YARRA CITY COUNCIL

Internal Development Approvals Committee

1.1	PLN18/0613 - 49-53 Bedford Street, Collingwood - Use (dwellings) and development of the land for a multi-storey building and removal of party wall easements
------------	---

1. This report provides an assessment of the proposed use (dwellings) and development of the land for a multi-storey building and removal of party wall easements at No. 49-53 Bedford Street, Collingwood.

Figure 9: western streetscape of Bedford Street (including 4-10 Stanley Street)

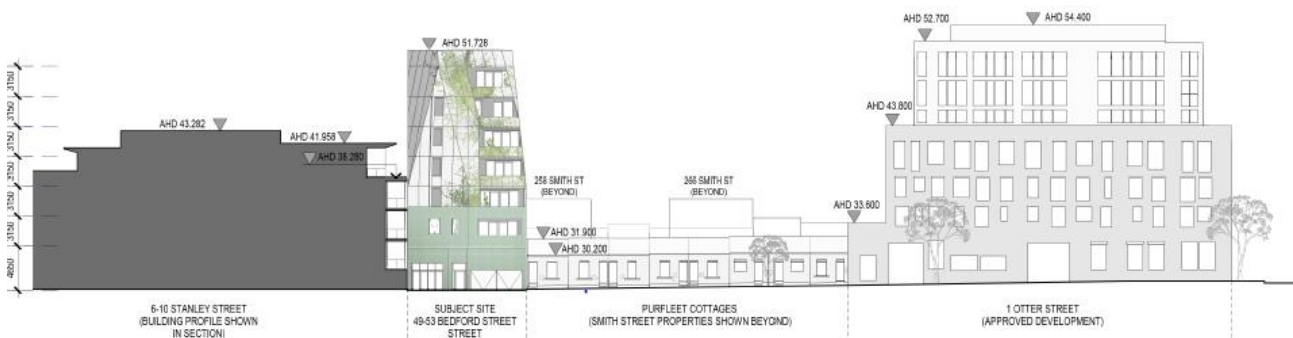
90. Figure 9 demonstrates how the development at the northern end of Bedford Street (1-5 Otter Street), whilst also extending to 7-storeys, has adopted reductions in height to the Purfleet Cottage interface, allowing for a more sensitive transition in scale along the streetscape. Of note, the direct abuttal to the northern-most cottage is only 1.7m higher than the cottage's roof. In comparison, this proposal would provide a wall 6.38m higher than the abutting single-storey cottage before any setbacks occur.

94. However, the scale of the proposal was not viewed as favourably from within Bedford Street itself, with Council's heritage advice acknowledging the height transition provided between the Purfleet Cottages and the Otter Street development to the north as discussed above. It noted that the setback between the cottages and the approved higher development (at 1-5 Otter Street) went *'someway to mitigate against over towering or being overwhelming'*. In contrast, this proposal does little to provide a more sympathetic transition in height.

99. On this basis, the Urban Design advice concluded that the proposed development would overwhelm the character of Bedford Street by creating an enclosed street environment at its southern end. It states that the maximum acceptable building height at this end of Bedford Street is five-storeys, using the development at 4-10 Stanley Street as a reference. On this basis, it was recommended to remove Levels 5 & 6 of the proposed development, thereby resulting in a maximum five-storey built form.

100. To combat the overwhelming nature of the development, Council's Heritage Advice also recommended a reduction in height, however this advice recommended the removal of Level 2. This change seeks to remove this level and drop the *'folded levels down to retain the basic shape and proportion of podium to tower'*. It was considered that the removal of a lower level would *'establish a better proportion to "Purfleet Cottages"'*.

Figure 12: proposed widening of pedestrian link

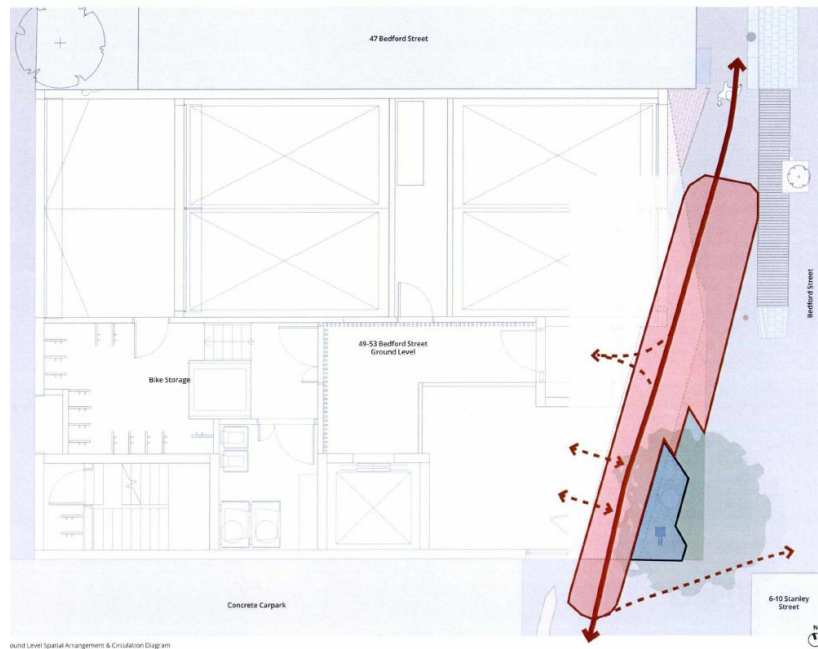
103. Clause 21.05 seeks new development to make a positive contribution to the enhancement of the public domain, whilst clause 22.10-3.4 aims to ensure that new development enhances public safety and the pedestrian experience by creating attractive and active interfaces.
104. The glazed façade to the ground floor shop addressing Bedford Street will provide an engaging frontage to this interface, with the south-facing window in this space creating surveillance opportunities to Rendle Place to the south. Further, the development seeks to improve the current pedestrian experience and connection from this laneway through to Bedford Street. Rendle Place currently provides little sense of place and minimal activation, with the proposed setback of the ground floor in the south-east corner opening up view-lines to this space.

Improved outlook and a more direct pedestrian flow will be provided, thereby allowing for a safer connection through this thoroughfare. This connection is demonstrated in Figure 12.

Figure 14: Width of required pedestrian link

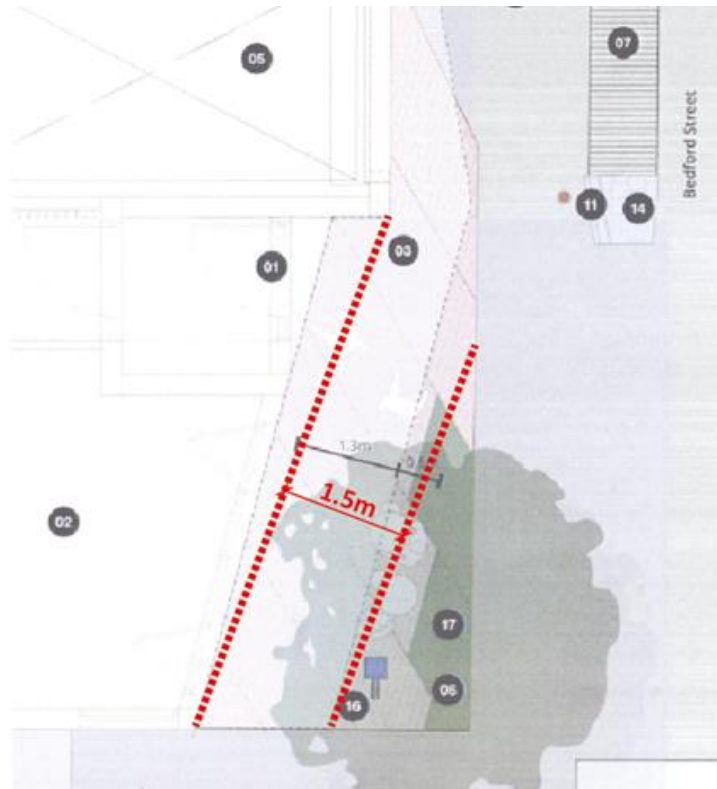
108. This advice notes that there is currently a 1.3m wide passageway between the subject site and 4-10 Stanley Street that is used for pedestrian access. An increase to a width of 1.5m is recommended, as outlined in Figure 14, to ensure that a clear path of travel is provided.

109. Figure 14 indicates that the 1.5m pathway is possible, with the dimensions of the bicycle repair station limited. Specifications provided for the repair station indicate that this infrastructure has a maximum width of 0.5m, including the signage at the top of the structure.

112. These recommendations are generally supported by Planning Officers (with the DDA requirements to be assessed at the building permit stage) however a degree of vegetation within this space is preferred if possible, to allow for a softening of the landscape and a substitute for the existing street tree, whilst maintaining pedestrian access. A condition can be added to any permit issued to incorporate these changes, with an additional condition requiring the provision of a landscape plan that demonstrates a reduced degree of landscaping within this space that works in conjunction with improved pedestrian circulation.
